**Panel Report**

**Greater Geelong Planning Scheme Amendment C335  
Highton, Belmont and Wandana Heights Special Building Overlay**

**1 August 2016**

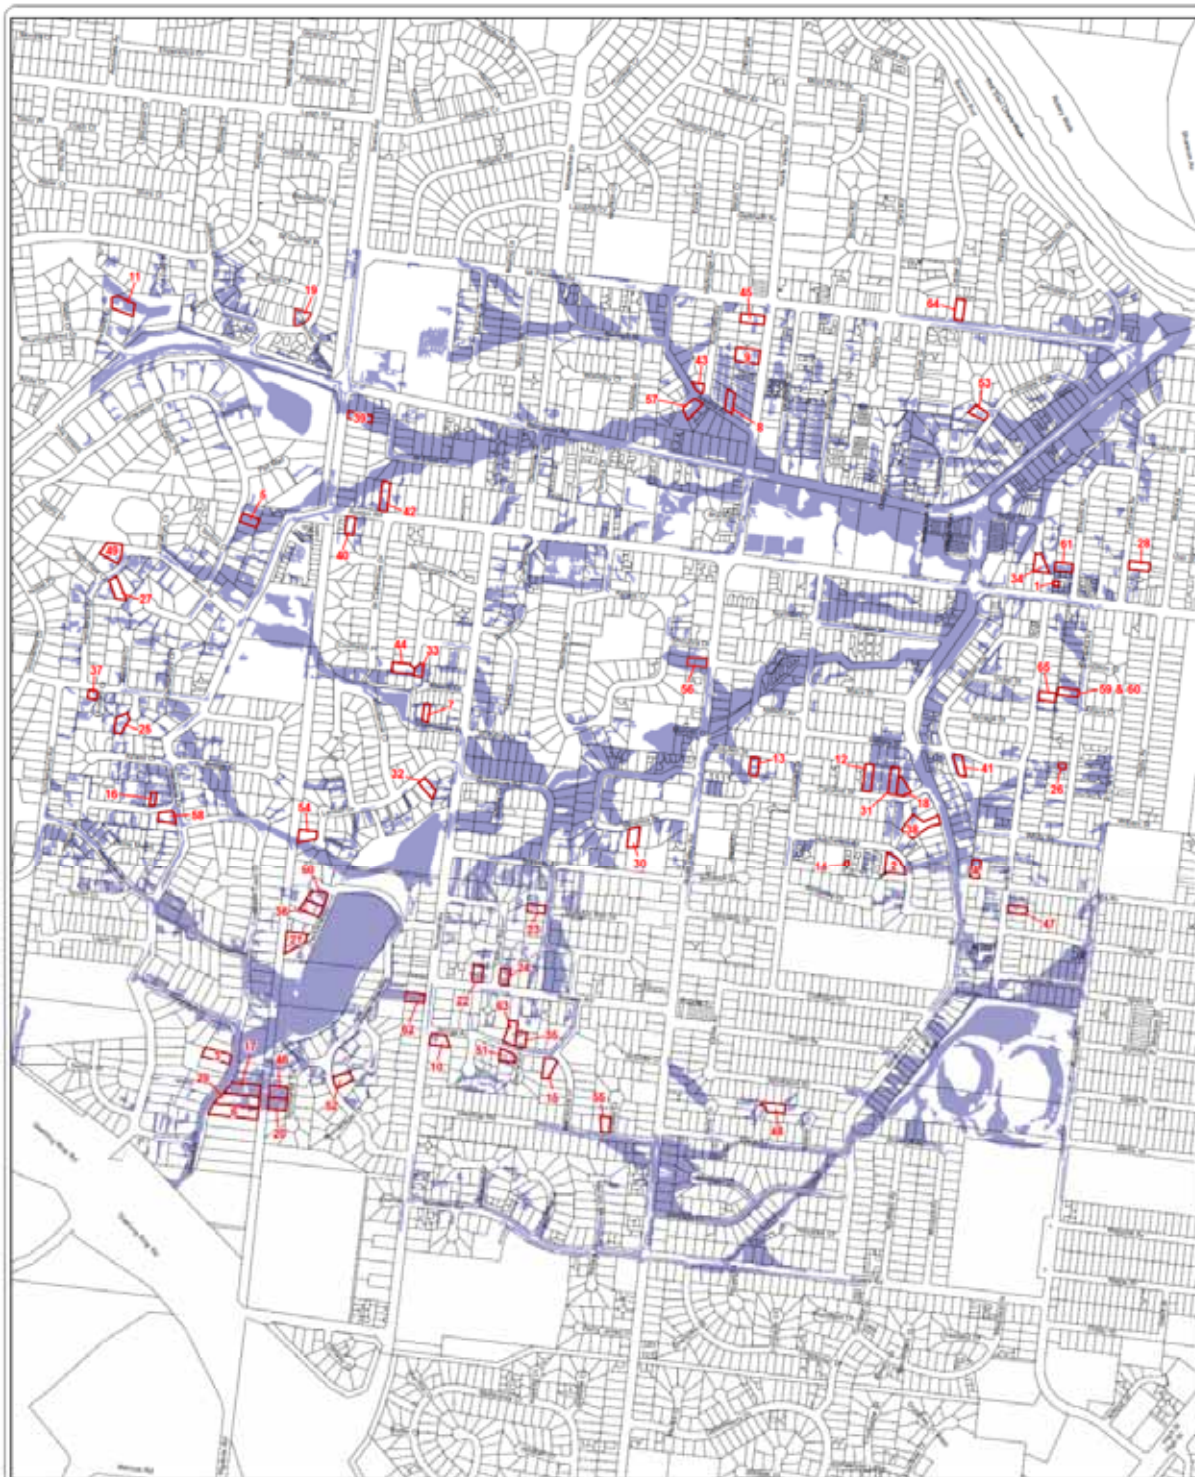
Post exhibition reviews of properties by Council determined that the SBO should be removed from seven properties at 1 to 6 Parkland Court and 2 The Mews. Council submitted that these properties could be removed as a result of recent drainage works in that area that is now expected to limit inundation of that area.

As part of that review, BMT WBM also provided a supplementary modelling report on 11 and 12 Summerhill Terrace and 14 Henderson Drive. These two areas were selected as Council determined that the road profiles could be more accurately modelled to reflect recent changes and that this may impact flood modelling. The review determined that four Summerhill Terrace properties should be removed from the SBO, but that 14 Henderson Drive should be retained in the SBO.

Appendix C shows all eleven properties proposed by Council to be removed from the SBO.

The Panel concludes that the properties as shown in Appendix C should be removed from the SBO.

**The Panel recommends that Amendment C335 to the Greater Geelong Planning Scheme be adopted as exhibited subject to the removal of the areas as shown in Appendix C of this report.**
